**CUSTOMER NOTICE OF PRODUCT/PROCESS CHANGE**

Customer Name:	All Customers
CTS Part Number:	<hr/> 220AMA04R, 220AMB04R, 220AMC04R, 220AMA10R 220AMB10R, 220AMC10R, 220AMA16R, 220AMB16R 220AMC16R, 220ADA04, 220ADB04, 220ADC04, 220ADA10, 220ADB10, 220ADC10, 220ADA16, 220ADB16, 220ADC16 <hr/>

**Description of Change:** New design of housing and terminal change with new shape, print on the surface and increase of thickness

**Table 1- Old Product Structure**

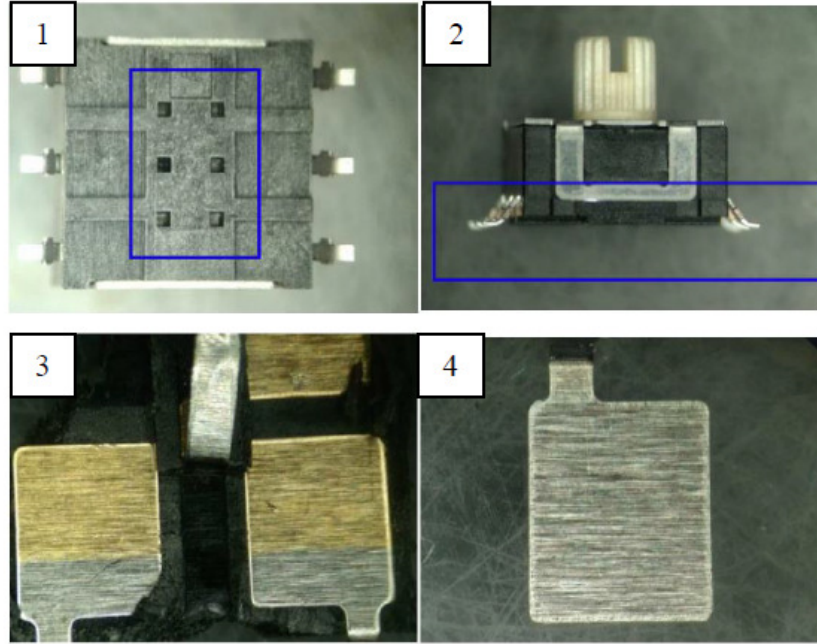
(1)6 holes at the bottom for plastic injection purpose.

(2)Terminal thickness was 0.15mm.

(3)No V shape notch on the terminal.

(4)No print of mark on the back of terminals.

(1)Block the holes on the bottom of housing and add the No. of output, which will prevent the flux to intruding..

(2)Increase the terminal thickness from 0.15 to 0.25mm, which will avoid terminal deformation in the application.

(3)Add the V shaped notch at the start of terminal. The V shaped will obstruct the flux to move to contact area.

(4)Add the print of mark on the back of terminals. The print of mark will obstruct the flux to move to contact area.
